Vivant

Range Modifications

Release date: August 1st 2001

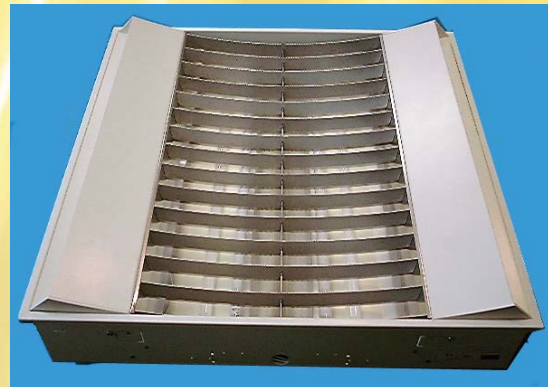
Vivant body construction has changed – becoming a one piece folded steel design.

Fully integral emergency gear has moved from the centre compartment, with painted metal cover, to a back access removable gear tray mounted behind the profiler.

The luminance profiler system, projecting light onto the ceiling, has been redesigned – improving the ceiling illumination.

- The opal plastic extruded upper diffuser, fixed behind/above the profilers, has been replaced by folded steel, painted to match the body.

Slight modifications have been made to the louvre.

- The louvre is now offered with 13 wedge blades for Retail and 15 wedge blades for Cat2 options.
- The louvre centre wedge now covers the control gear - eliminating the need for a separate cover.
- Aluminium louvre material has been upgraded from 610G3 to MIRO6.
- Louvre now comes fitted with dog-tag safety cords.
